<b>Subject:</b>  MIL ON / P2004 SETS AFTER STARTING ENGINE	<b>Bulletin No:</b> 01-055/06
	<b>Last Issued:</b> 12/20/2006

2004-2005 Miata

2004-2005 MAZDASPEED MX-5

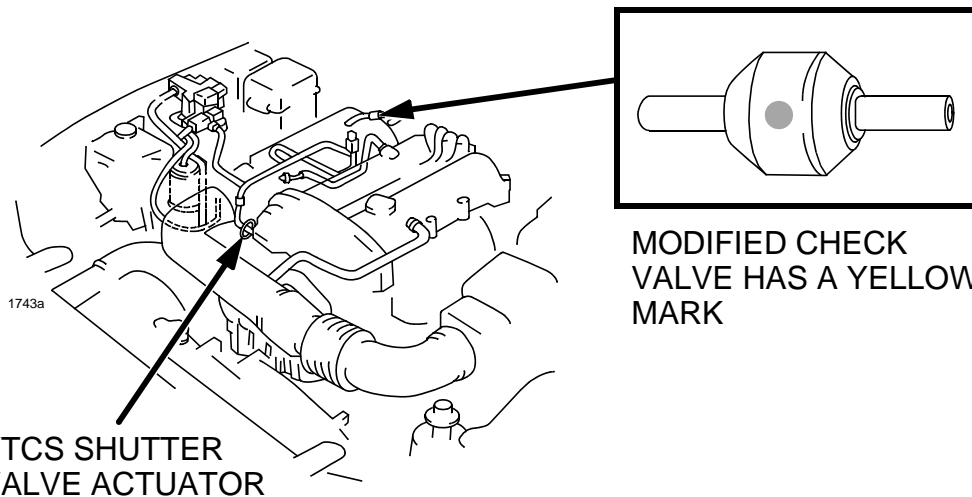
On some vehicles, after sitting overnight and started, the MIL comes on and DTC P2004 sets into PCM memory. This occurs because vacuum (momentarily) does not flow into the Variable Tumble Control System (VTCS) shutter valve actuator. The contact surface between the valve and the valve body inside the check valve is smooth causing the valve to momentarily stick before more vacuum applies, opening the valve.

As a mass-production change, the contact surface between the valve and valve body has been made rougher to prevent sticking condition. Customers having this concern should have their vehicle repaired using the following repair procedure.

1. Verify customer concern.
2. Replace check valve with a modified part.

- Modified check valve can be identified by Yellow marking on the valve body.
